PM21

STRA 2: Draft Land South of Mickleover Mixed Use Allocation

**Regulation 19 Modifications to STRA2 Consultation - Land South of Mickleover
PM16/PM21/PM22/AM72**

STRA2 Indicative Layout (Original Regulation 19 Allocation Framework)

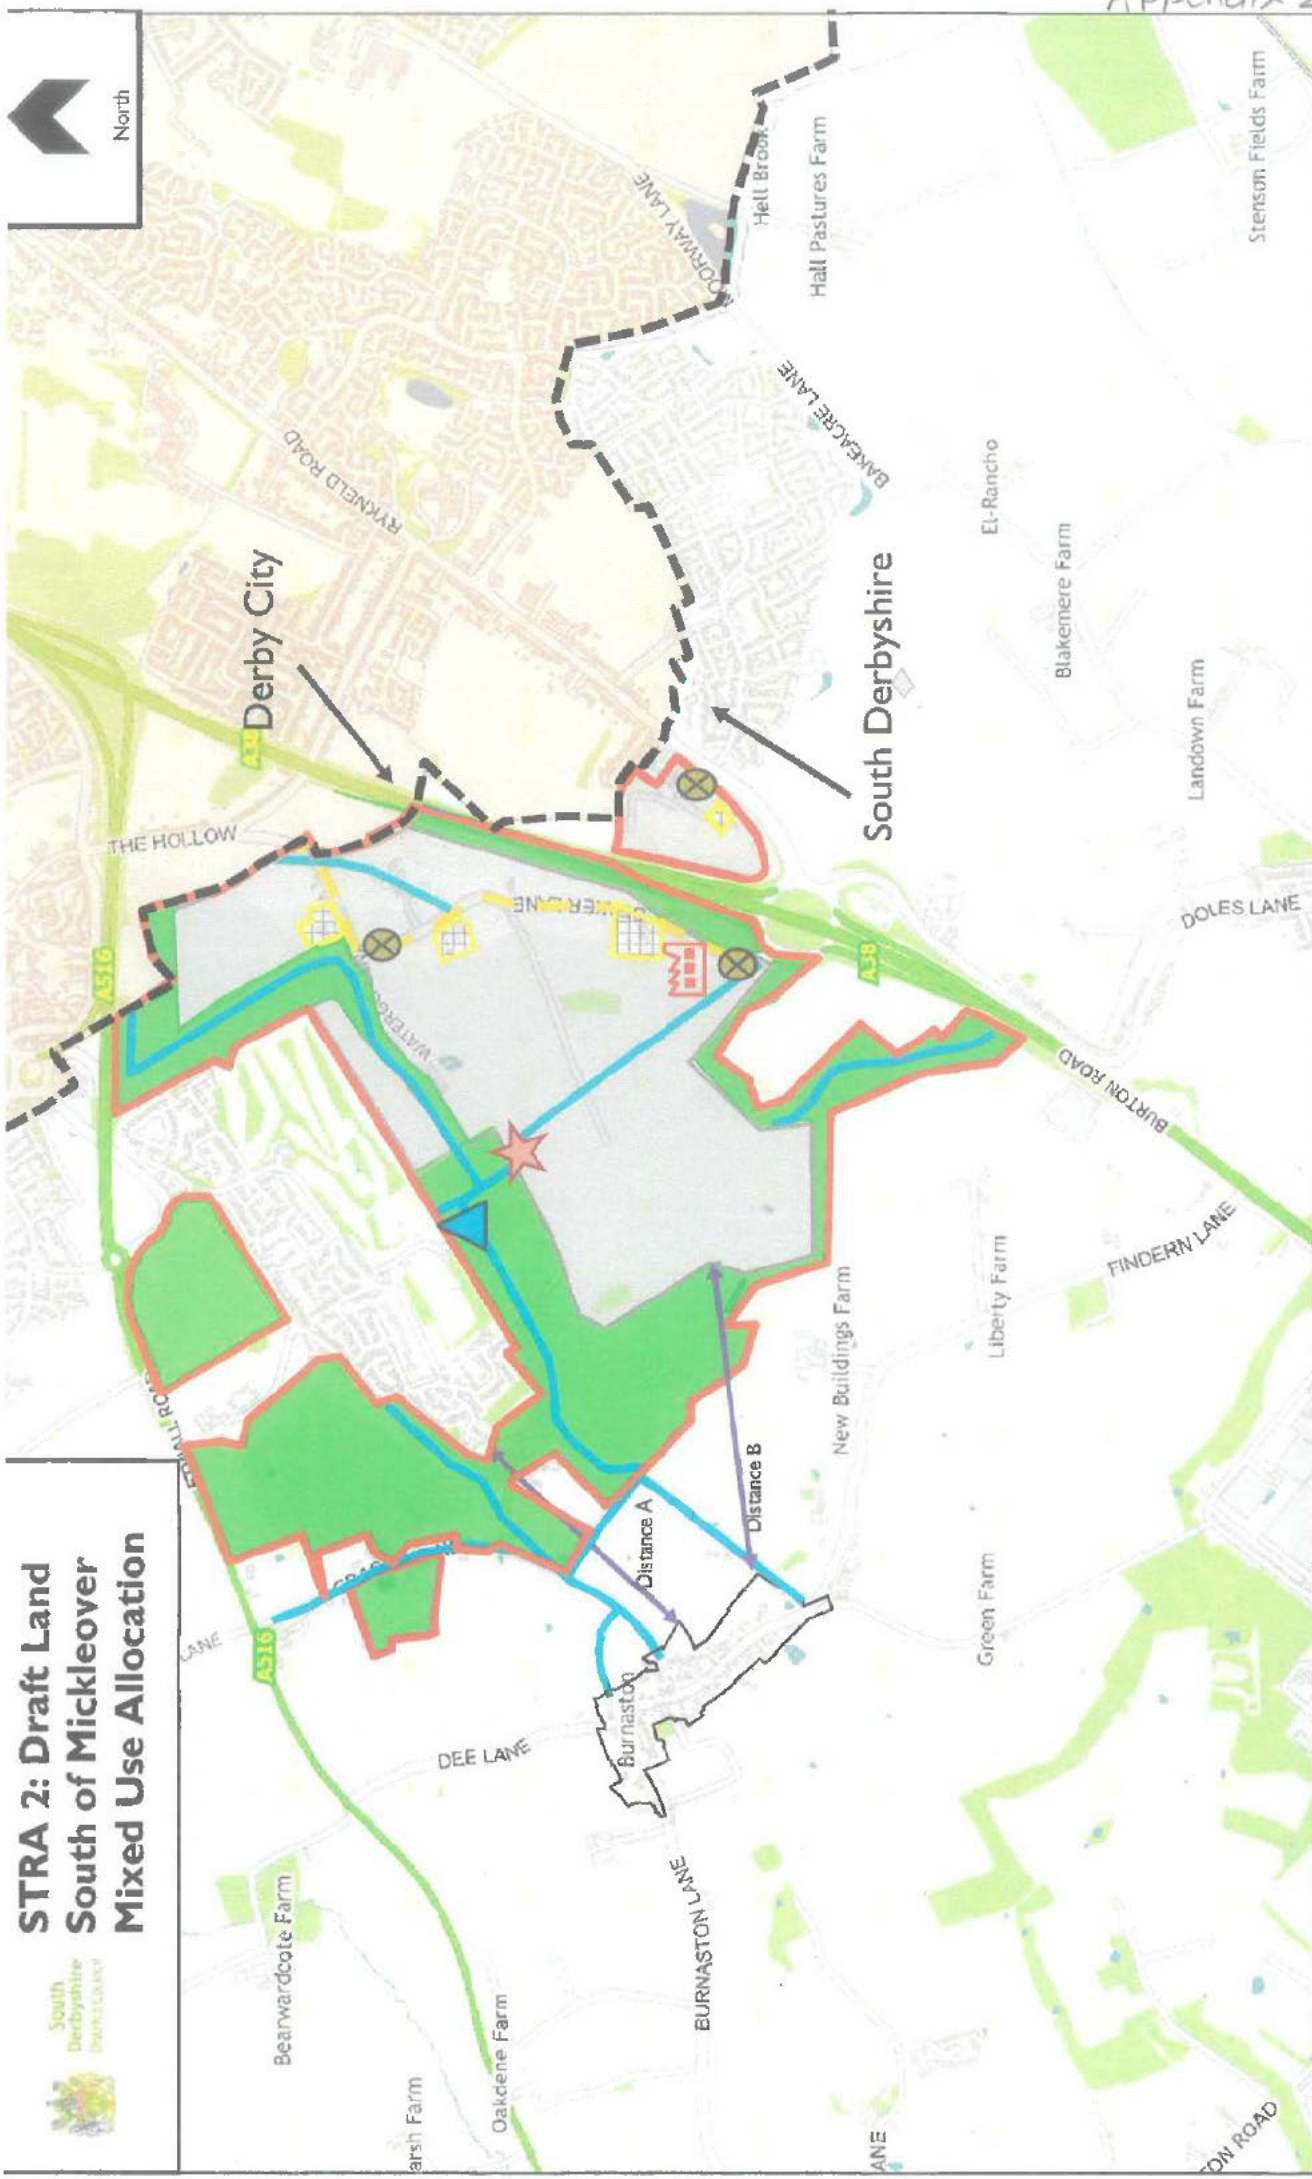
The PM22 map is insufficiently clear, inaccurate in certain respects and potentially misleading and therefore does not allow consultees to properly understand the proposed modifications, the function of the land shown on the map, the relationship between the various land use designations and the spatial implications of the proposals.

- residents note that the explanatory text accompanying AM73 anticipates some more limited development fronting the A516. This appears to represent a material spatial change to the distribution of development within the allocation from the original Regulation 19 indicative map. However, neither PM22 nor the supporting evidence clearly explains the planning rationale for this change, identifies the scale, extent, density or form of that development, or explains how it relates to the wider Green Infrastructure and Country Park framework. Consultees are therefore unable to properly understand the implications of this element of the proposal or provide fully informed representations upon it during the consultation process;

Residents therefore consider that these issues are not merely cartographic concerns but relate directly to consultation clarity, interpretation of the proposals and the ability of consultees to provide informed representations and fair public engagement.

Residents respectfully request that PM22 is amended to provide a clearer and more comprehensively annotated plan showing the purpose, extent and function of all proposed land use designations, corridors and infrastructure.

- provide a clear and intelligible legend explaining all symbols, annotations and corridor features;
- clearly identify the purpose and function of the purple square symbols and ensure that their location accurately reflects the position of the features they are intended to represent;

- provide sufficient information to allow consultees to understand the proposed modifications and submit informed representations.
